SAFETY EVALUATION REPORT
OF THE
NINE MILE POINT UNIT 1 NUCLEAR POWER STATION
DOCKET NO. 50-220

ISSUED: December 27, 1974

APPENDIX A
NINE MILE POINT UNIT 1
- OPERATING RESTRICTIONS

FIGURE A-1 MAXIMUM AVERAGE PLANAR LINEAR
HEAT GENERATION RATE VERSUS
PLANAR AVERAGE EXPOSURE

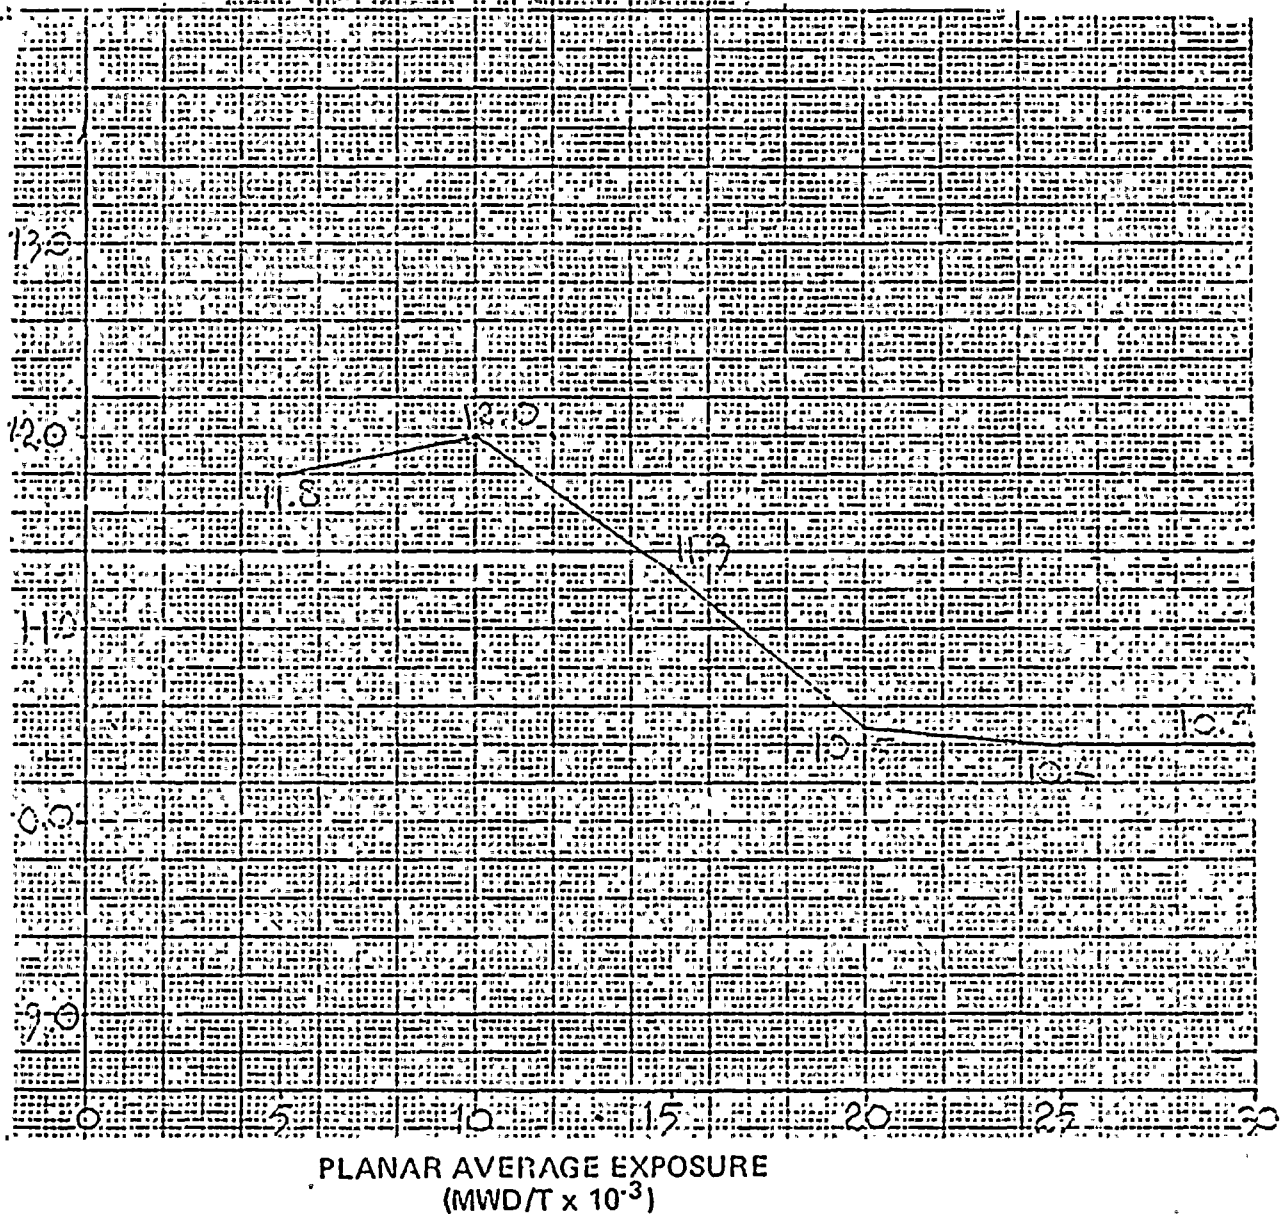
The limiting value of MAPLNHR included with the proposed Technical Specifications submitted on August 2, 1974 has been revised to account for the General Electric ECCS Evaluation Model deficiencies which have been discussed in this report. The revised values are given in Figures A-1 through A-5. Operation should conform to these values.

Operation should also conform to a limiting MCPR value of 1.19.
